## 3.4 LOCAL AGENCIES

Re: Martis Valley West Parcel Specific Plan Project – Draft Environmental Impact Report Comment Letter

**Re: Comments on Draft Environmental Impact Report (DEIR)  
 Martis Valley West Parcel Specific Plan (MVWPSP)**

**LA7-6**

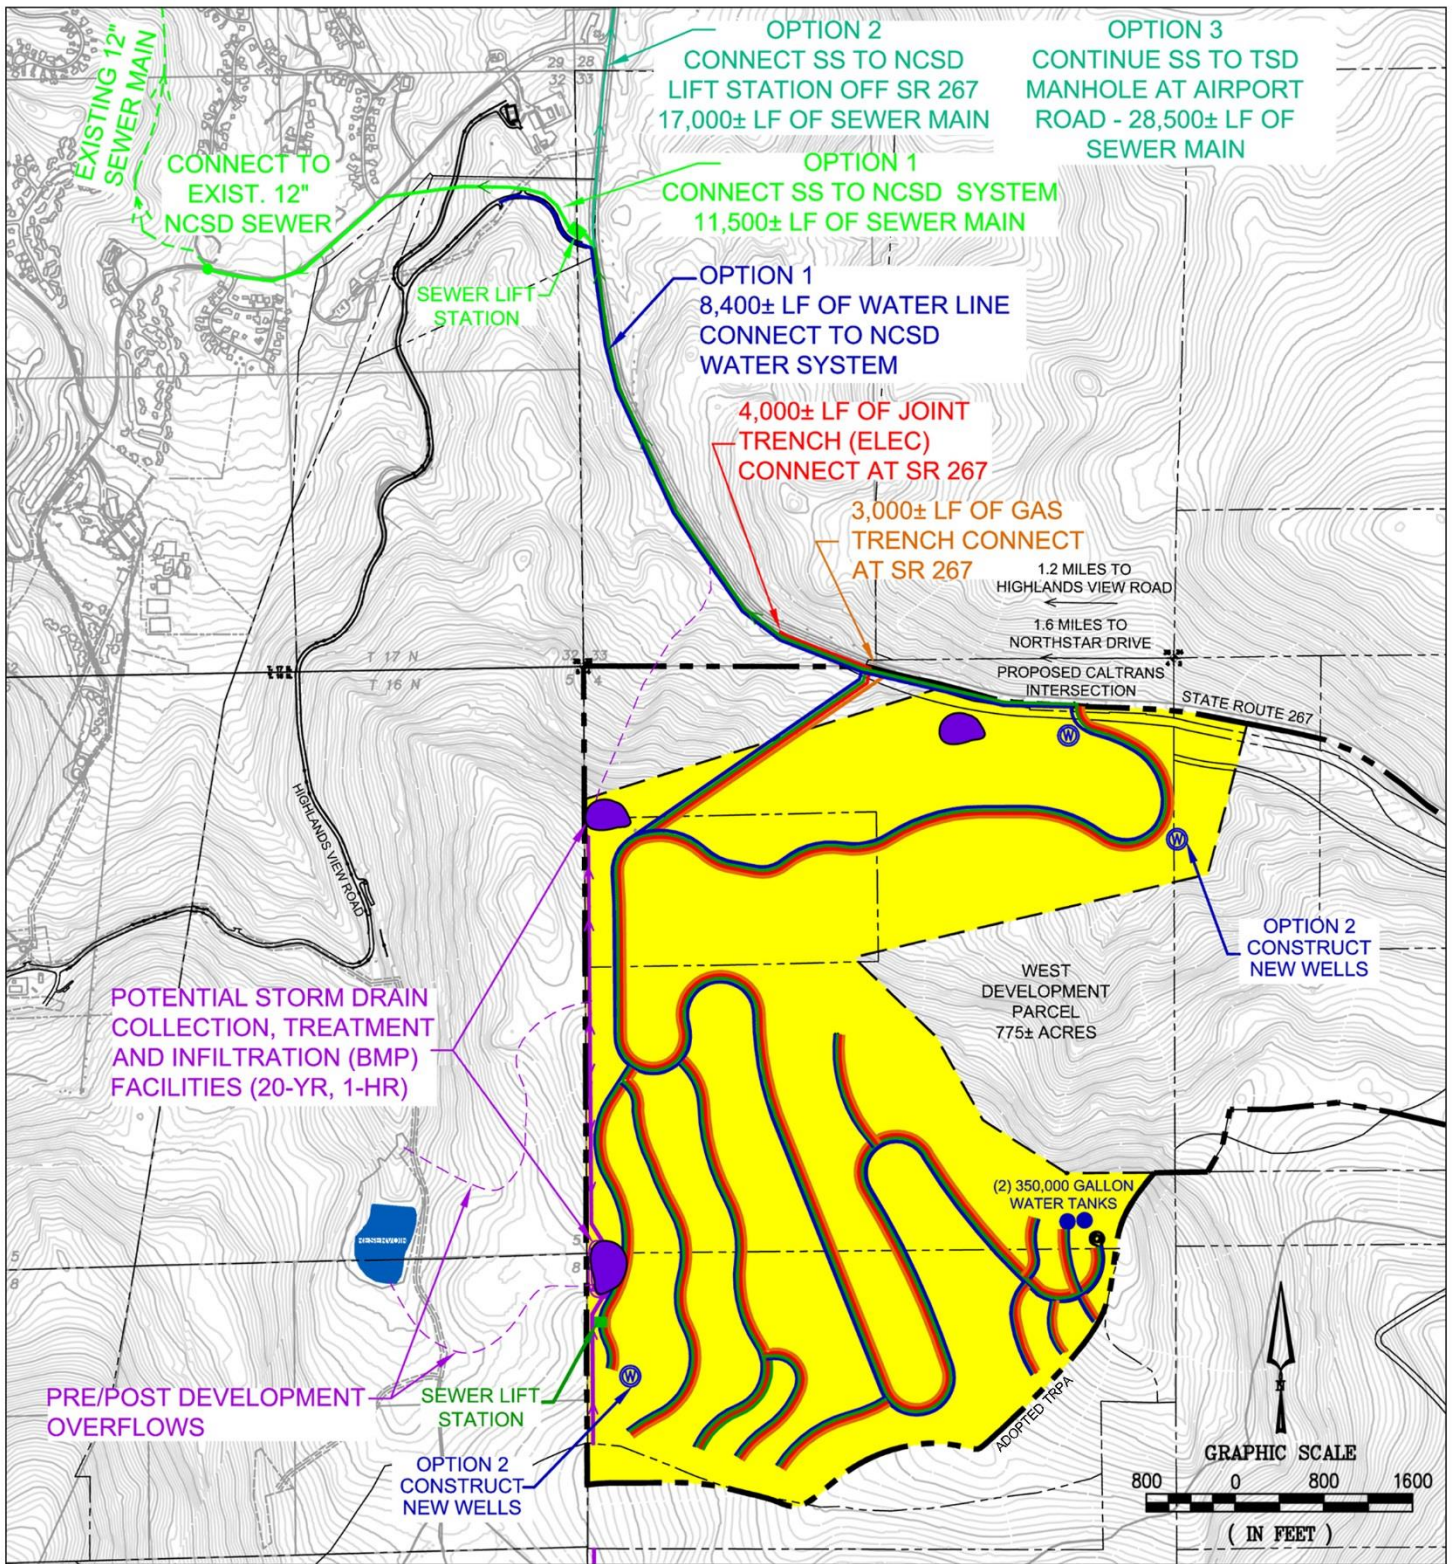
- Exhibit 3-12 does not show the location of sewer lines located within project streets and NCSD easements as indicated in the text. This text should either be corrected or the exhibit updated. LA7-2

| <p>2. <u>Exhibit 3-12, “Proposed Utility Connections” (Page 3-26).</u> The Exhibit should be revised to reflect the following:</p> <ul style="list-style-type: none"> <li>• It is very difficult to understand the sewer options as shown in the Exhibit since they are all shown in the same color. Do the options have overlapping infrastructure?</li> <li>• There is no NCSD sewer lift station in the location shown on the Exhibit.</li> <li>• The text on Page 3-27 indicates that the Exhibit shows 6-inch and 8-inch sewer lines located within the West Parcel area streets and NCSD utility easement. No such information is provided in the Exhibit.</li> </ul>   | <p>LA7-5</p>           |

The comment requests that Exhibit 3-12 of the Draft EIR show the location of sewer lines located within project streets and NCSD easements. Exhibit 3-12 has been revised as shown on the following page. It should be noted that Exhibit 3-12 and 16-2 are the same; therefore, Exhibit 16-2 is also revised to reflect the locations of the internal sewer lines. Please also see Chapter 2, "Revisions to the Draft EIR," of this Final EIR.

The comment recommends that Exhibit 3-12 of the Draft EIR be revised to reflect overlapping infrastructure, the location of a new sewer lift station, and sewer lines within project streets. Exhibit 3-12 has been revised as shown in response to comment LA7-2, above.

LA7-19

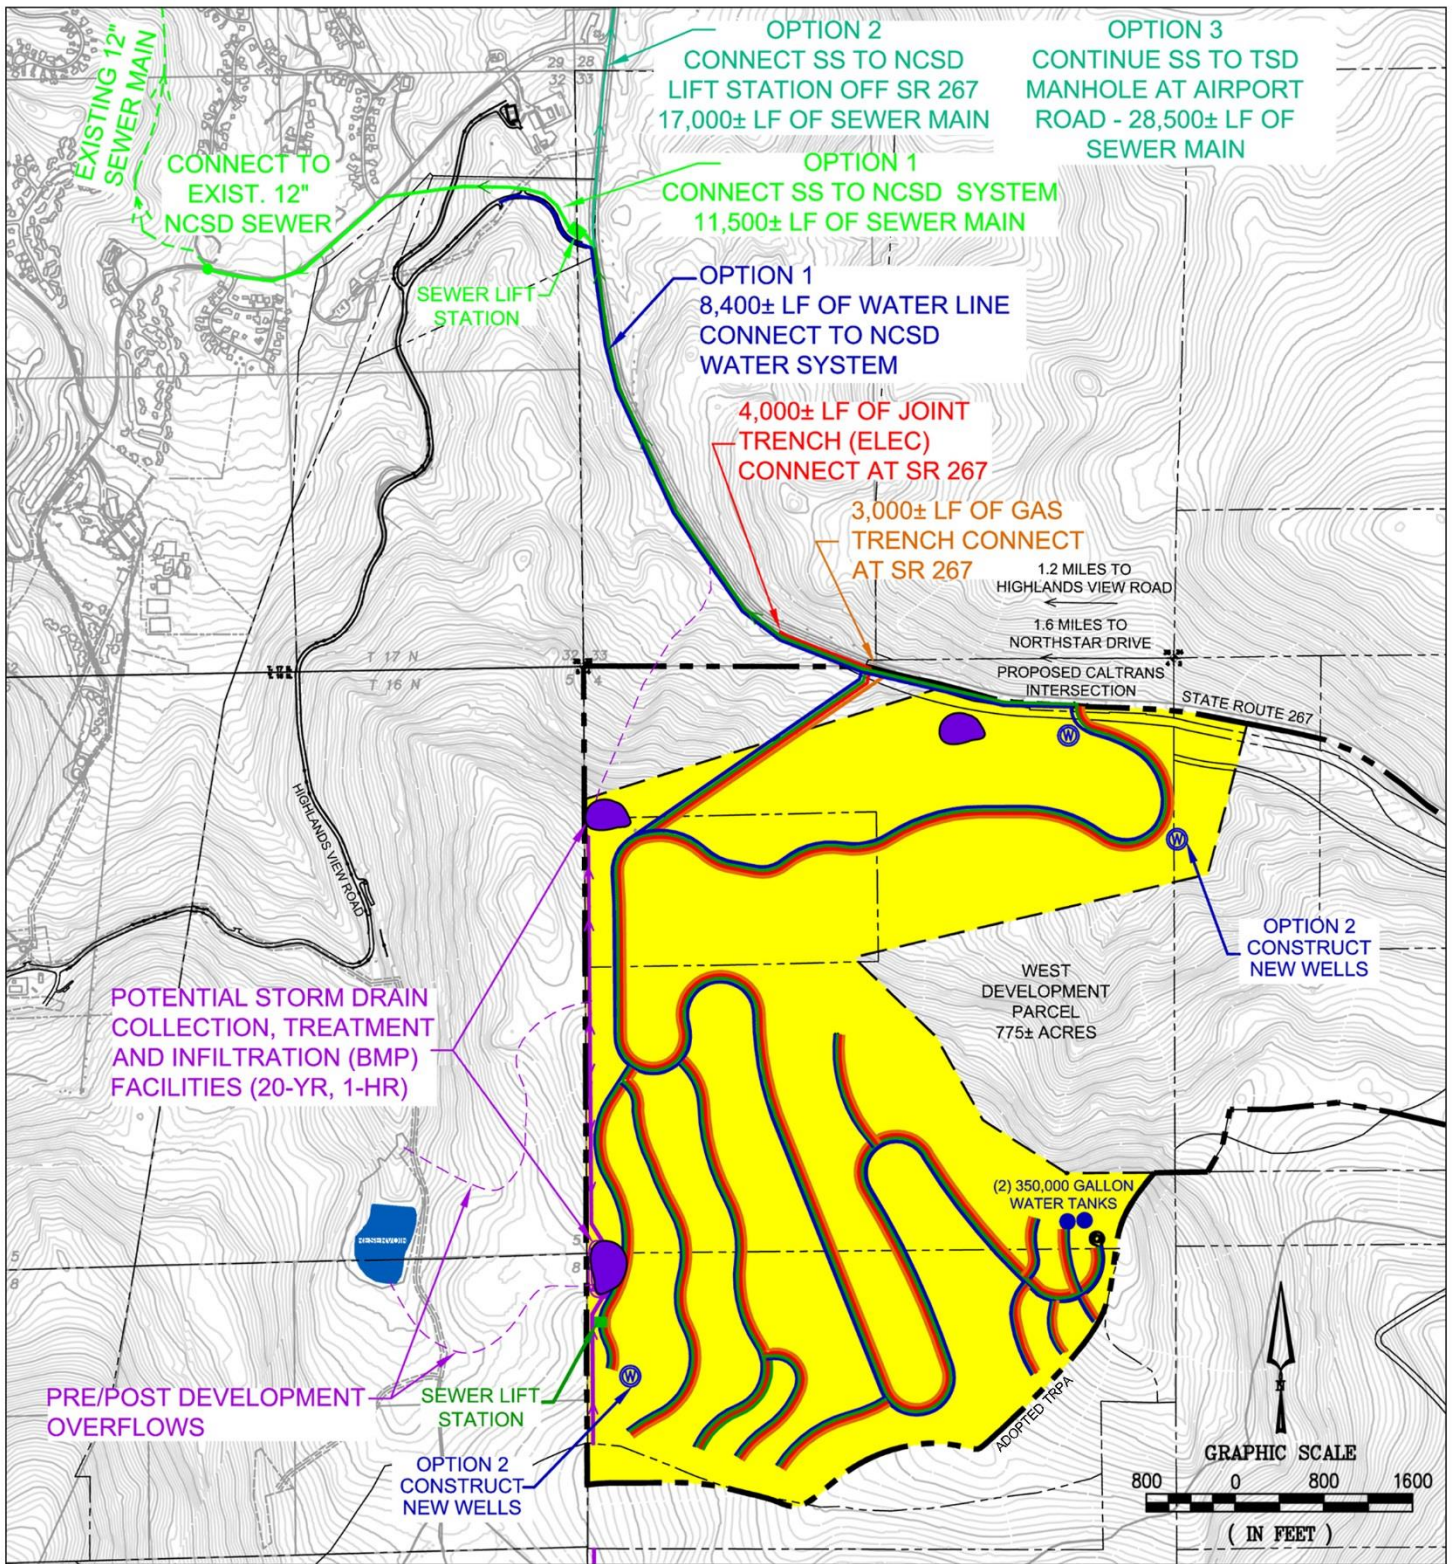
| <ul style="list-style-type: none"> <li>• The paragraph references Exhibit 16-2 and states that it shows the sewer lines in project streets and NCSD easements. Exhibit 16-2 does not show the sewer lines.</li> </ul>  | <div style="border-left: 1px solid black; height: 100px; margin: 0 auto; width: 10px;"></div> | LA7-19         |

| <p>This paragraph, Exhibit 16-2, or both, should be revised to match with accurate values.</p> <ul style="list-style-type: none"> <li>This paragraph indicates that a new sewer lift station would be located in the northeast portion of the West Parcel development area. No such lift station in this location is shown on any exhibit.</li> </ul>   | <p>LA7-19<br/>cont.</p> <p>LA7-20</p> |

The comment requests that Exhibit 16-2 show the sewer lines in project streets and NCSD easements. Exhibit 16-2 has been revised to show these sewer lines as shown on the following page on Revised Exhibit 16-2.

- LA7-20 The comment recommends that Exhibit 16-2 of the Draft EIR show the location of a new sewer lift station in the northeast portion of the West Parcel. Exhibit 16-2 has been revised as shown in response to comment LA7-19, above.

- LA7-22 The comment requests that Exhibit 16-2 of the Draft EIR be updated to indicate the required upsizing of the pipeline under SR 267 through the Martis Valley and the NCSD pump station. The comment notes that the pipeline components do not line up with those indicated in Table 16-12. Exhibit 16-2 has been revised as shown in response to comment LA7-19 above.
